Title - Sujet IRB Float and Derrick Landing	
Solicitation No. - N° de l'invitation F1700-174408/A	Amendment No. - N° modif. 003
Client Reference No. - N° de référence du client	Date 2017-09-01
GETS Reference No. - N° de référence de SEAG PW-\$PWY-026-8149	
File No. - N° de dossier PWY-7-40055 (026)	CCC No./N° CCC - FMS No./N° VME
Solicitation Closes - L'invitation prend fin at - à 02:00 PM on - le 2017-09-08	Time Zone Fuseau horaire Pacific Daylight Saving Time PDT
F.O.B. - F.A.B. Plant-Usine: <input type="checkbox"/> Destination: <input checked="" type="checkbox"/> Other-Autre: <input type="checkbox"/>	
Address Enquiries to: - Adresser toutes questions à: Yi (PWY), Patty	Buyer Id - Id de l'acheteur pwy026
Telephone No. - N° de téléphone (778) 919-2578 ()	FAX No. - N° de FAX (604) 775-6633
Destination - of Goods, Services, and Construction: Destination - des biens, services et construction: DFO - IRB Float and Derrick Landing - Nootka Light Station - Yuquot, BC

Amendment 003

Amendment 003 has been raised to incorporate Addendum 002.

NOOTKA LIGHTSTATION - IRB FLOAT AND DERRICK LANDING ADDENDUM 2

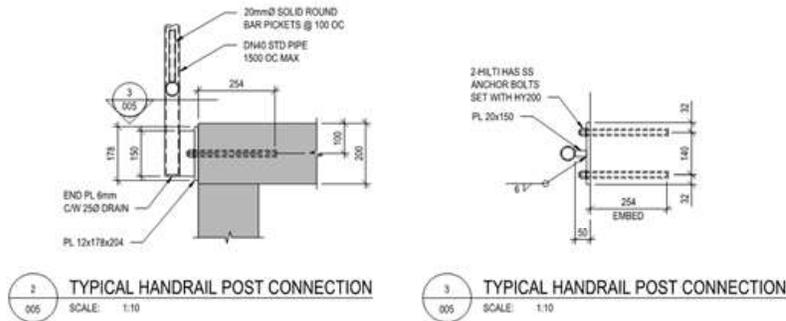
In regards to the handrail, detail 2/005 in DWG DL-005 is not called out on the layout. Please advise.

The handrail referenced in Detail 2 on Drawing NL-DL-005 is located on each side of the upper landing on the lower stair.
